**Power System Planning & Appraisal-I Division**

**Subject: Minutes of the 3<sup>rd</sup> meeting of Western Regional Power Committee (Transmission Planning) [WRPC(TP)]**

### **Minutes of the 3<sup>rd</sup> Meeting of Western Regional Power Committee (Transmission Planning) held on 14.06.2021 through Video Conferencing**

### Khavda PS- I, II & III Schematic Diagram

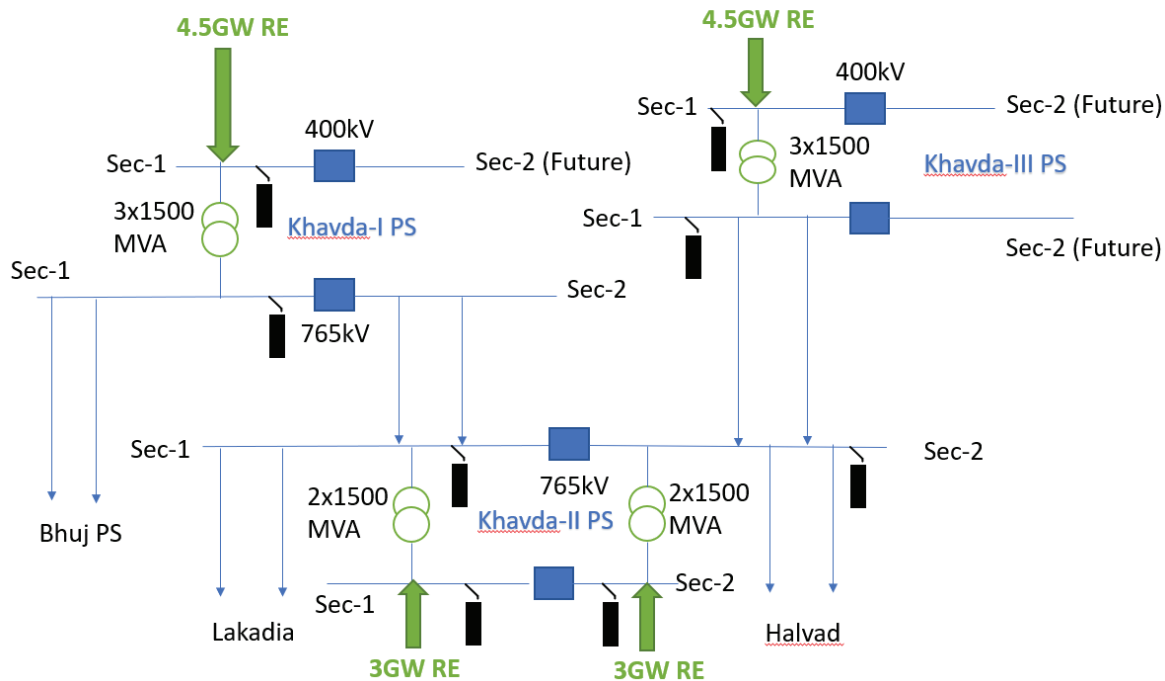
- 9.6. SECI stated that at Khavda Pooling Station 3 (KPS3), no provision of 220 kV level has been made. As SECI would be developing only wind RE projects, therefore injection of wind power at KPS3 may be planned at 220 kV level.

- 9.7. CTU stated that providing connectivity at 220 kV level to RE projects in Khavda would not be an optimal planning strategy. Moreover, providing connectivity at 220 kV level may limit the corridor availability for transmission corridor in the Khavda RE park.

- 9.9. CEA stated that Khavda pooling station 1 (KPS1), which has already been agreed, included creation of 220 kV level but the same has been dropped from the scope of works as the RE developer has been granted connectivity at 400 kV level. Accordingly, Khavda pooling station 2 and 3 have been planned to provide connectivity to RE developers at 400 kV level. However, only space provision would be kept in the pooling stations for 400/220 kV ICTs to take care of any future drawal requirement.

### A. Under ISTS:

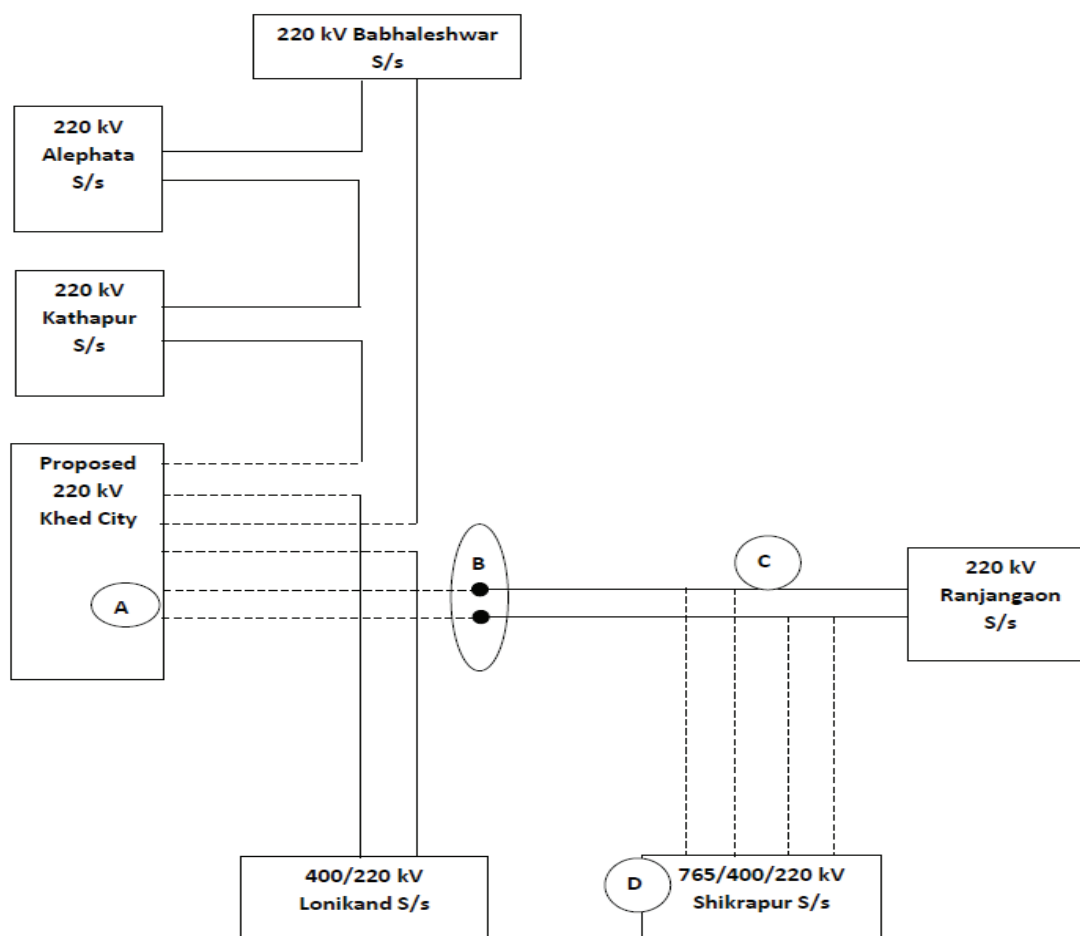
10.1. CEA stated that in the 2<sup>nd</sup> meeting of WRPC (TP) held on 04.09.2020, the proposal of creation of 220 kV level at 765/400 kV Pune GIS (Shikrapur) Substation by MSECTL was discussed. The proposal included following elements:

- (i) 220 kV level creation at 765/400 kV Pune GIS (Shikrapur) S/s along with 2x500 MVA, 400/220 kV ICT at 765/400 kV Pune GIS (Shikrapur)
- (ii) 220 kV line bay - 4 nos. at 765/400 kV Pune GIS (Shikrapur) S/s.

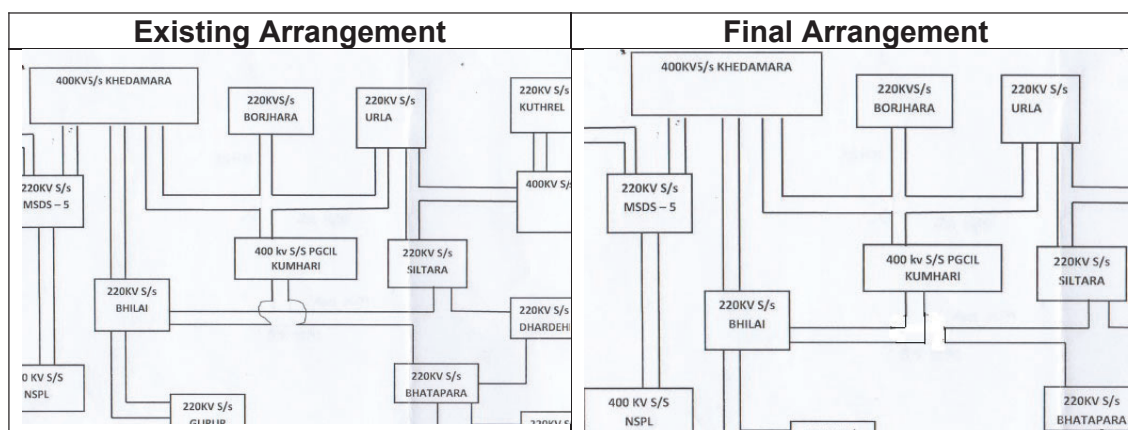
- Along with swapping of 400 kV ckts Raipur (PG), CSPTCL to carry out the following re-arrangement of 220 kV lines to increase 220 kV feeds to Bhilai 220 kV substation:

Re-arrangement of 220 kV Bhilai – Bhatapara S/c line & 220 kV Raipur – Siltara S/c line so as to form 220 kV Bhilai – Raipur D/c line & 220 kV Bhatapara – Siltara S/c line- By CSPTCL

- CSPTCL had shown willingness to implement the swapping works with their own resources in view of the severe load management problem being faced by them due to restricted drawl capacity from ISTS.
- Scheme agreed in principle and the same would be taken up for ratification by WRPC(TP). Regarding the implementation modalities of the scheme, CSPTCL to deliberate with PGCIL and convey their decision wrt implementation of the scheme by CSPTCL or as an ISTS scheme
- Existing configuration and configuration after re-arrangement is as given below:

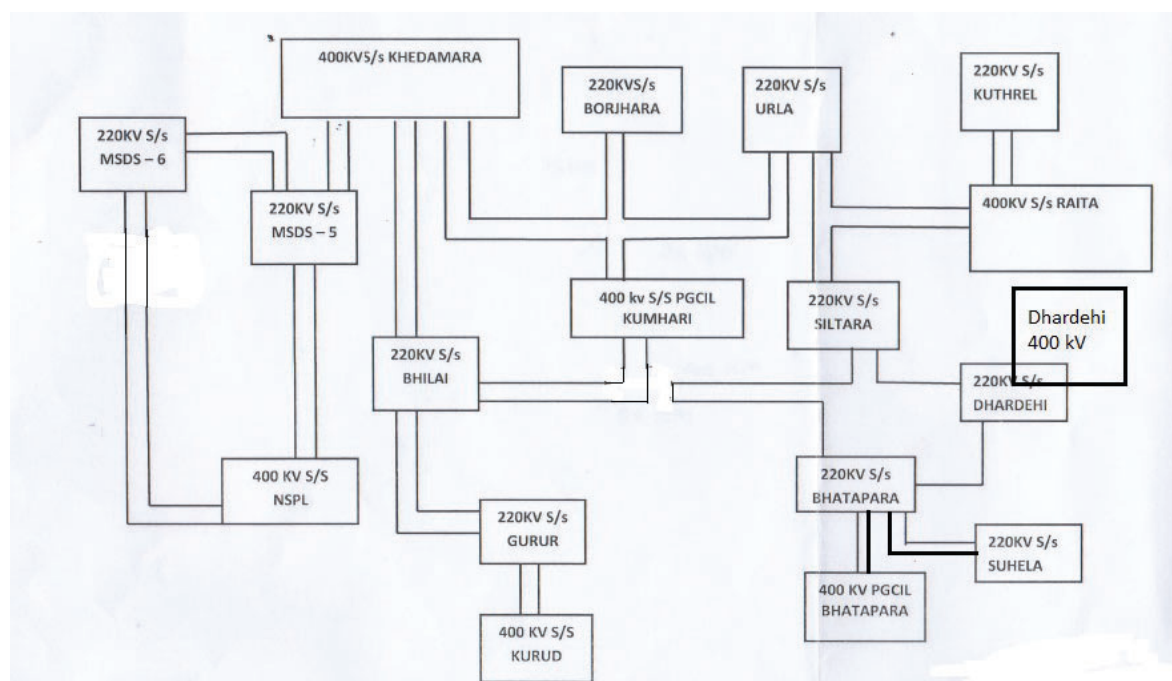
(iii) In addition CSPTCL would take up the implementation of the following schemes as Intra-state strengthening scheme:

- Establishment of 400 kV Dhardehi S/s by LILO of one circuit of 400 kV Korba(W) – Raita D/c line and 400 kV Sipat – Dhardehi D/c line. Proposal would be included in the agenda for the next WRPCTP meeting.
- LILO of one ckt of 220 kV Bhatapara (PG) – Suhela line at Bhatapara (CSPTCL).
- The single line diagram showing proposals at (ii) and (iii) is as given below:

## **21. Scheme to control fault level at Indore S/s**

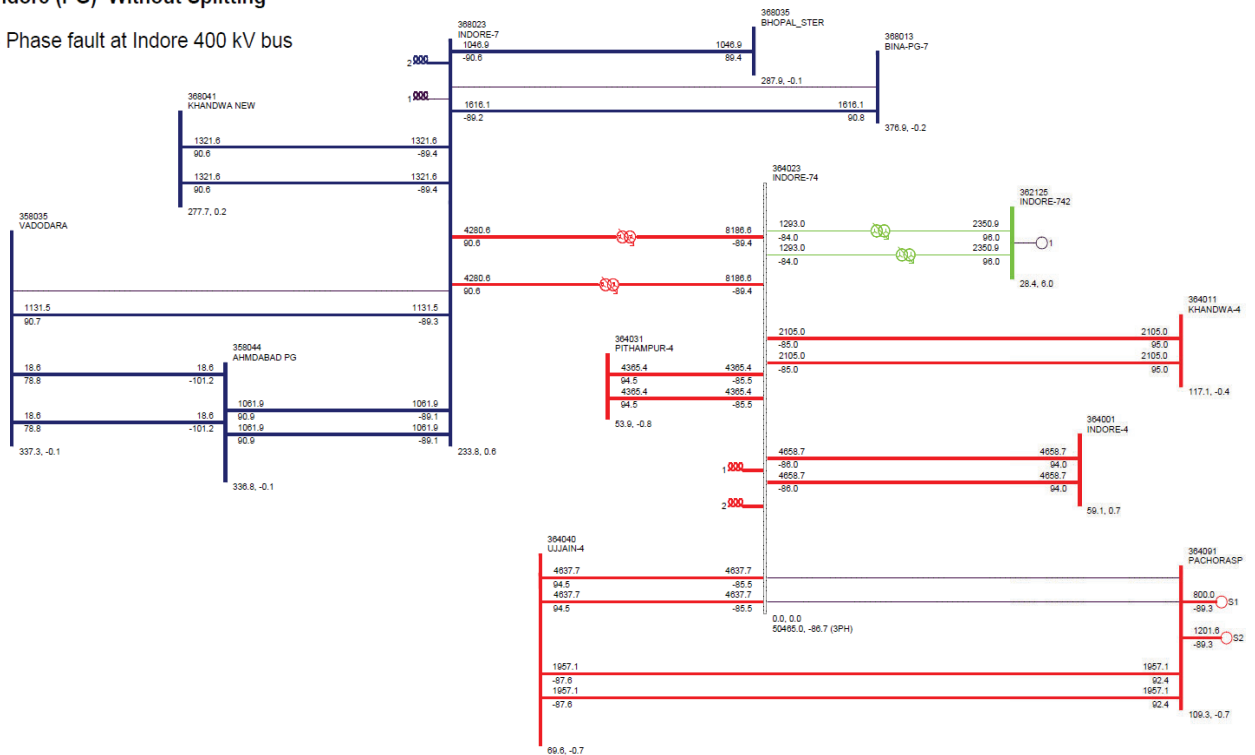
**21.1.** CEA stated that Indore 765/400/220 kV S/s in MP acts as a node for transfer of power from generation projects in MP and Gujarat to load centres in MP through high capacity 400 kV and 765 kV networks. A large number of RE generation projects are coming up in Gujarat whose power is getting dispersed through various substations (at 765kV level) including Indore (PG) for onward transfer of power to other parts of the grid resulting in high short circuit levels of interconnected grid. Short circuit level at Indore (PG) 400kV substation in 2022-2023 time-frame crosses 50 kA which is designed at 40kA. Even in the current time-frame, the fault level is about 42 kA.

Contributions from various 400kV lines can be seen from the diagram below (for high RE scenario):

- **Alternative-1:** Bus Splitting without disturbing the existing lines/ICTs at Indore(PG) S/s
  - Section-A: 36kA & Section-B: 26kA

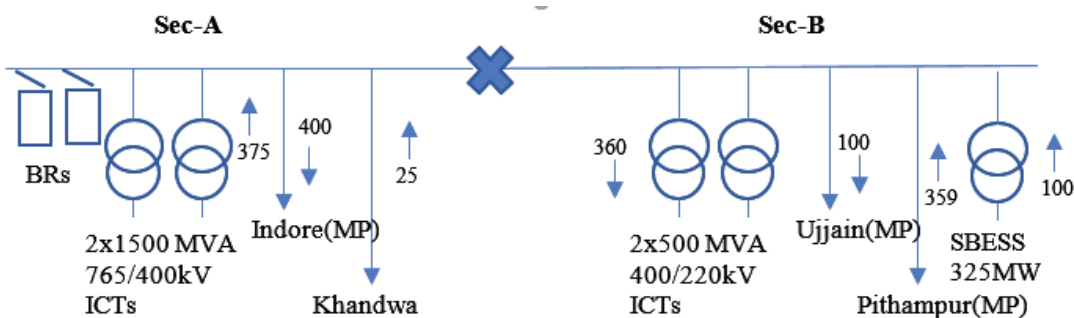
Diagram along with flows for peak load case is given below. Flow on sectionaliser when closed is 127 MW:

Power flow is not well balanced in both Alternatives 1 and 6. Further, **Alternative-6** requires line shifting which would be difficult to implement due to layout constraints. In each of the above cases, 1x125MVA bus reactor would be required in section B.

Among the three alternatives, power flow is balanced in both the sections in **Alternative-4** i.e. closing bus sectionaliser does not lead to significant flow from one

- **Alternative-4:** Bus Splitting along with shifting of 765/400 kV, 1X1500MVA ICT to Section B (through jumpering arrangement)
  - Section-A: 30 kA & Section-B: 36 kA

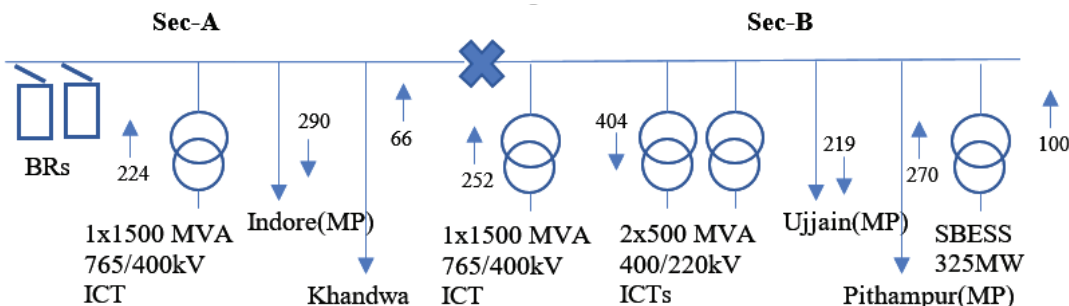
Diagram along with power flows for peak load case is given below. Flow on sectionaliser when closed is only 15 MW:

- **Alternative-6:** Bus Splitting along with swapping of Indore (PG)-Pithampur 400 kV D/c line (to Section A) and Indore (PG)- Indore(MP) 400 kV D/c line (to Section B)
  - Section-A: 34 kA & Section-B: 27 kA

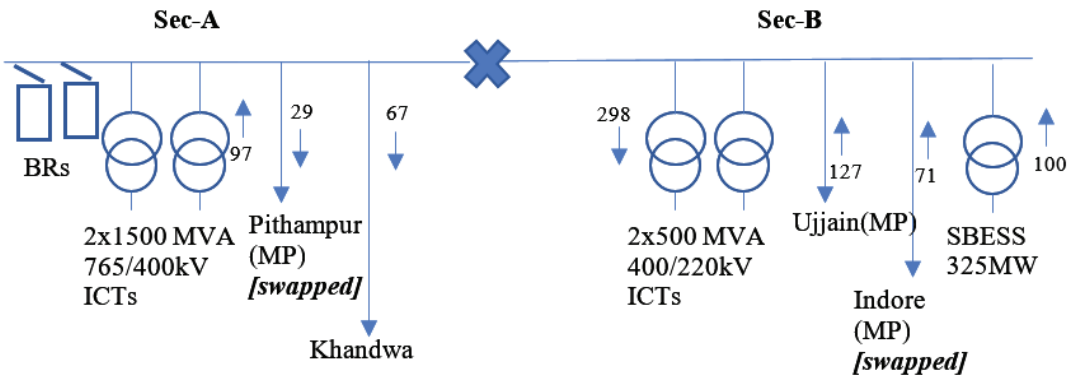
Diagram along with flows for peak load case is given below. Flow on sectionaliser when closed is 395 MW:

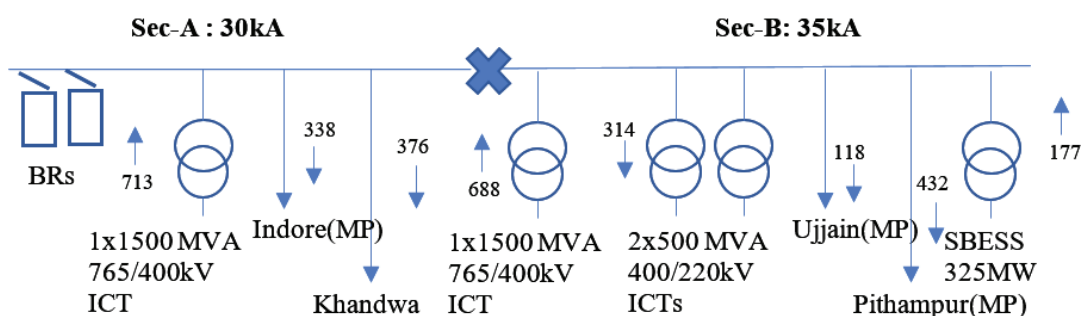
The splitting arrangement has also been studied for **Alternative-4** in **2024-25 High RE scenario (Afternoon Peak)** and SC level / flows are obtained as follows:

No issues were observed under 'n-1' of 765/400 kV ICT in either section.
